RECALL 17V-328: E65/E66 (7 SERIES) DOOR LATCHES

This Service Information bulletin supersedes SI B51 24 17 **dated January 2018**

RE: Recall 17V-328: Door Latches

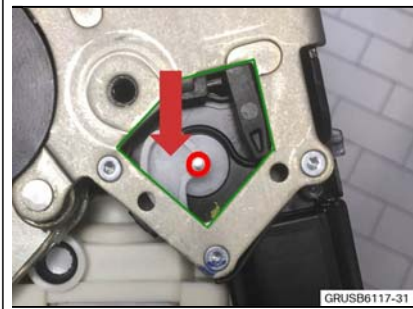
CORRECTION

- Select the conversion "Conversion, Comfort Access without Electric Opening" and Program the vehicle with ISTA/P 3.63.3 (I-Level E065-17-11-520) or higher
- Remove and modify the 4 door latches

2. Once the door lock is removed, modify each lock by removing the white or yellow opening assist cam (red arrow).

3. Manually position the cam so that it is clearly visible in the opening.

4. Cut the head of the cam retainer off with a pair of cutters.

5. Slide the cam off and discard using a pair of needle nose vice grips.
